Meeting 5&6

Comment Discussion

P802.3ck Chief Editor

120G (C2M) Topics

Figure 120G-9—Example module stressed input test

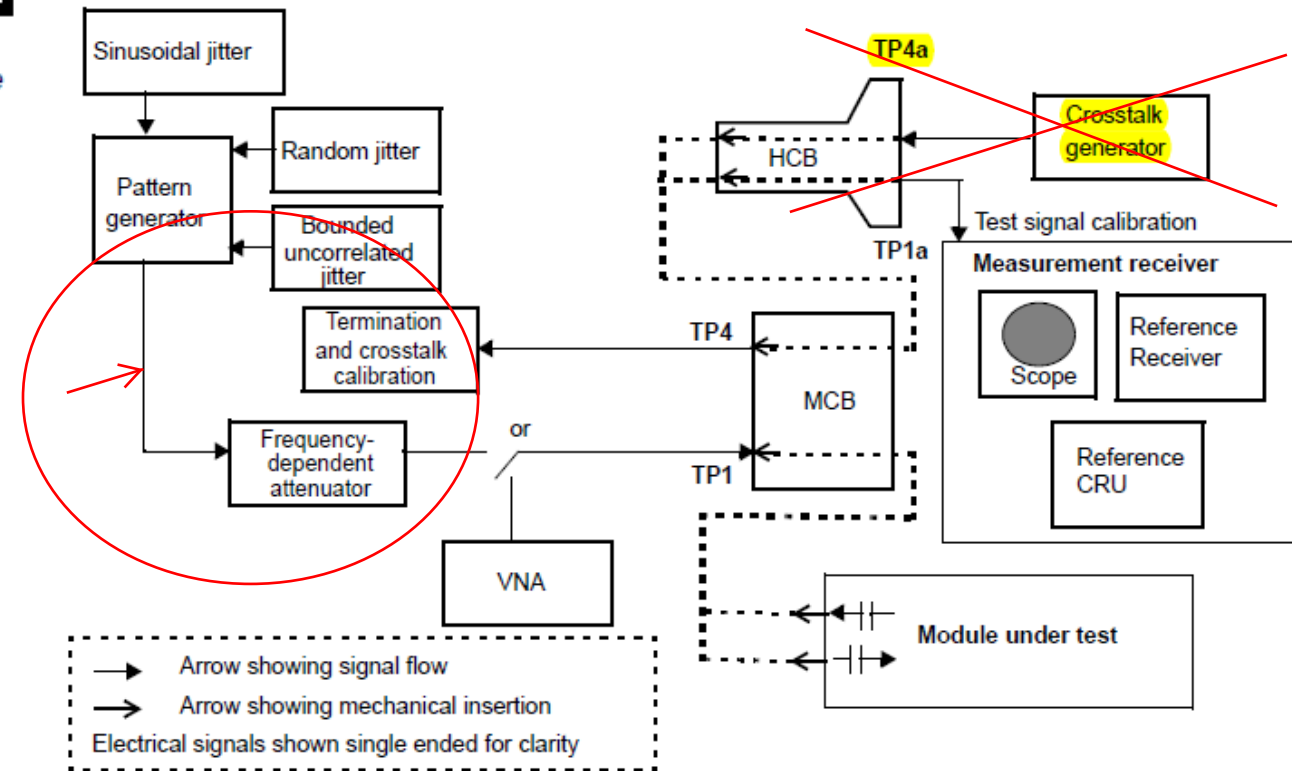
For the module input stressed eye, the pattern generator transition time value is TBD as follows:
"The target pattern generator 20% to 80% transition time at the input to the test channel in the module stressed input test is TBD ps."

Replace TBD with 7.5 ps.

The suggested value is consistent with the value used in the COM configuration file used for comparative COM simulations. Implement the suggested remedy. For task force review.

Figure 120G-6—Example host output test configuration

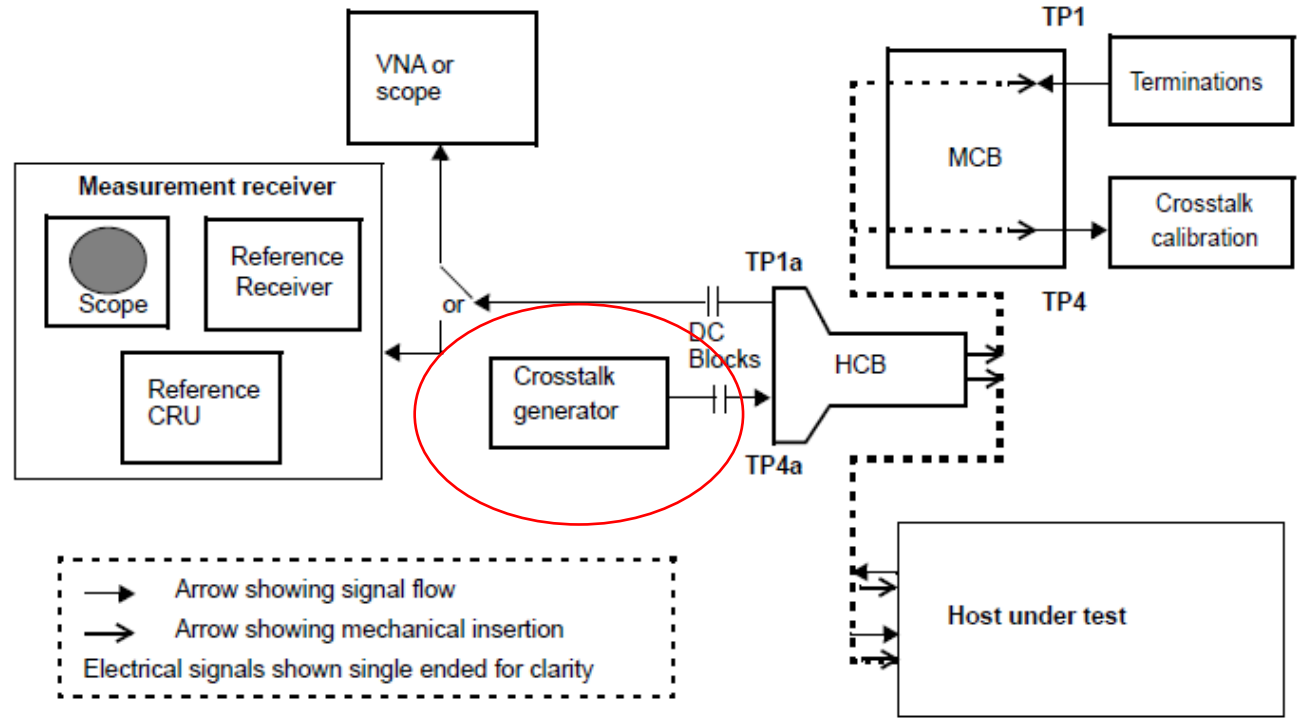
The parameter values for the host output eye opening crosstalk source are TBD as follows: "The crosstalk generator is calibrated at TP4 (without the use of a reference receiver) with target differential peak-to-peak amplitude of TBD mV and slew time of TBD ps between -TBD V and +TBD V." Use the maximum peak to peak value from Table 120G-1, range of 20% to 80%, and minimum transition time from Table 120G-1 (value proposed in another comment).

Replace with the following:
 The crosstalk generator is calibrated at TP4 (without the use of a reference receiver) with target differential peak-to-peak amplitude of 870 mV and slew time of 7.5 ps between -261 V and +261 V.

[Editor's note: Addresses incomplete specification.]
 Implement the suggested remedy.
 For task force discussion.

Figure 120G-7—Example module output test configuration

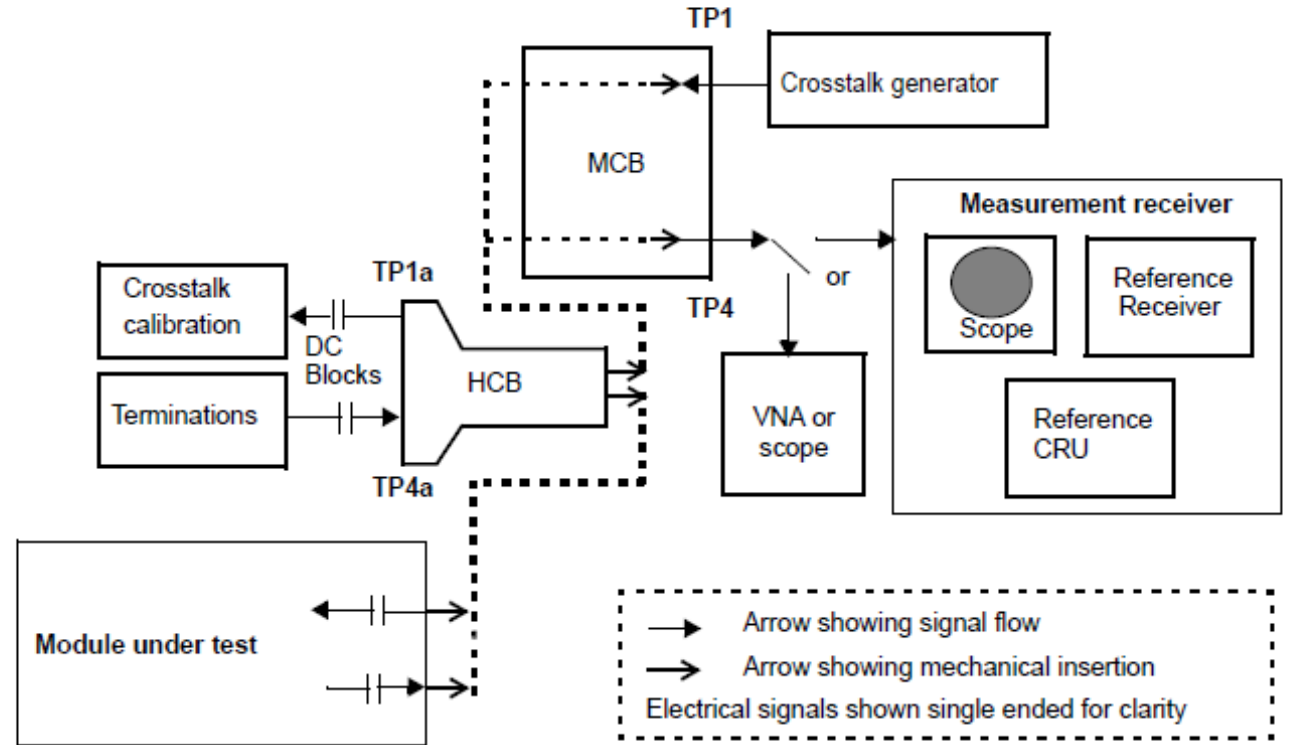
The parameter values for the module output eye opening crosstalk source are TBD as follows:
 "The crosstalk generator is calibrated at TP1a (without the use of a reference receiver) with target differential peak-to-peak amplitude of TBD mV and target transition time of TBD ps."
 Use the maximum peak to peak value and minimum transition time value (proposed in another comment) from Table 120G-1.

Replace with the following:
 "The crosstalk generator is calibrated at TP1a (without the use of a reference receiver) with target differential peak-to-peak amplitude of 900 mV and target transition time of 7.5 ps."

[Editor's note: Addresses incomplete specification.]
 Comment #91 proposes a maximum transition time of 7.5 ps.
 Implement suggested remedy.
 For task force discussion.

Figure 120G-8—Example host stressed input test

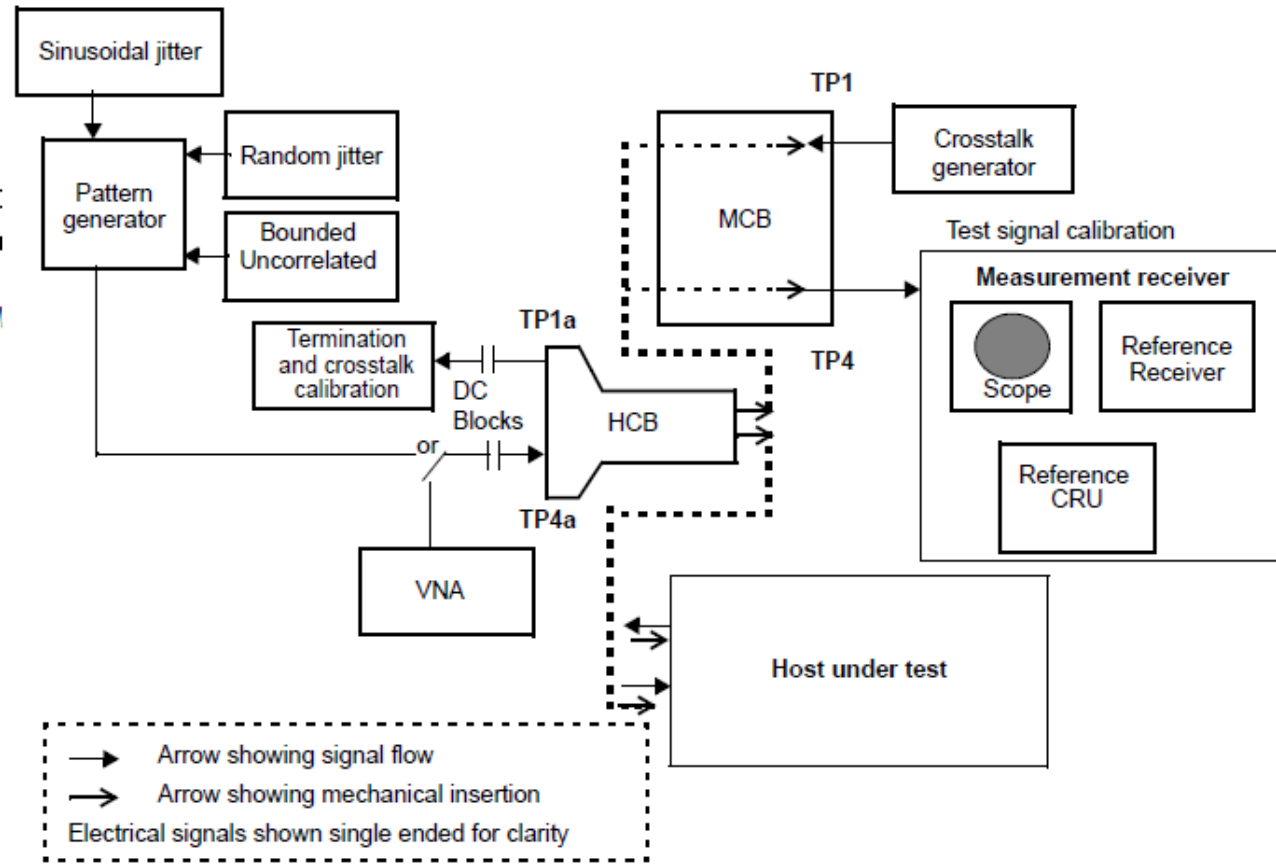
For the host stressed input the crosstalk source transition parameters are TBD as follows: "The counter propagating crosstalk signals during calibration of the stressed signal are asynchronous with target amplitude of TBD mV peak-to-peak differential and 20% to 80% target transition time of TBD ps as measured at TP1a (without the use of a reference receiver)." Set amplitude to the host output maximum value and set the transition time to the host output minimum value.

Change the sentence to the following: "The counter propagating crosstalk signals during calibration of the stressed signal are asynchronous with target amplitude of 870 mV peak-to-peak differential and 20% to 80% target transition time of 7.5 ps as measured at TP1a (without the use of a reference receiver)."

Implement the suggested remedy.

Figure 120G-9—Example module stressed input test

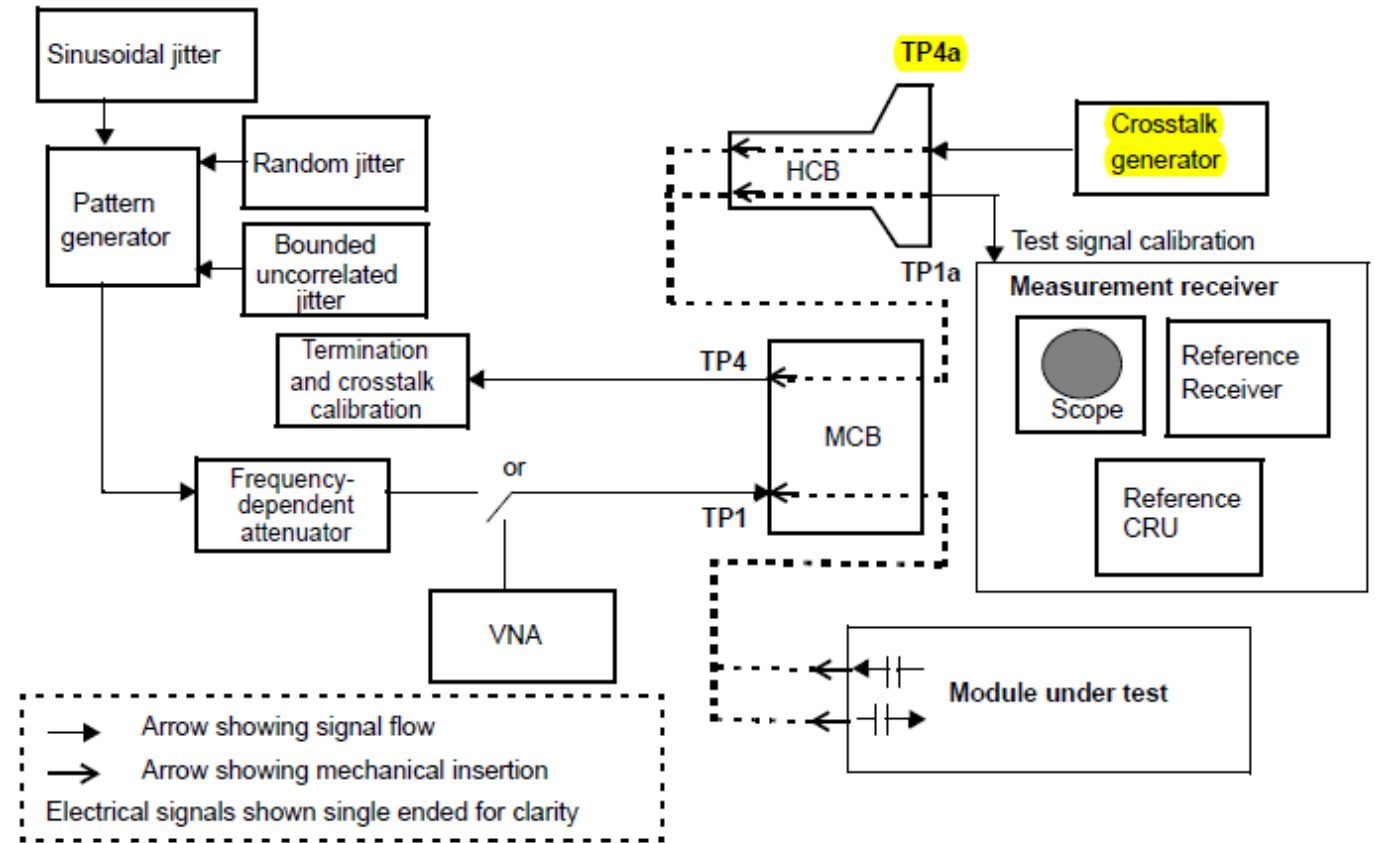
The parameter values for the module input eye opening crosstalk source are TBD as follows:

"The counter propagating crosstalk signals during calibration of the stressed signal are asynchronous with target amplitude of TBD mV peak-to-peak differential and target slew time between -TBD mV and TBD mV of TBD ps as measured at TP4 (without the use of a reference equalizer)."

Use the maximum peak to peak value from Table 120G-3, range of 20% to 80%, and minimum transition time from Table 120G-3 (value proposed in another comment).

The crosstalk generator is calibrated at TP4 (without the use of a reference receiver) with target differential peak-to-peak amplitude of 900 mV and slew time of 7.5 ps between -270 V and +270 V.

Implement the suggested remedy.
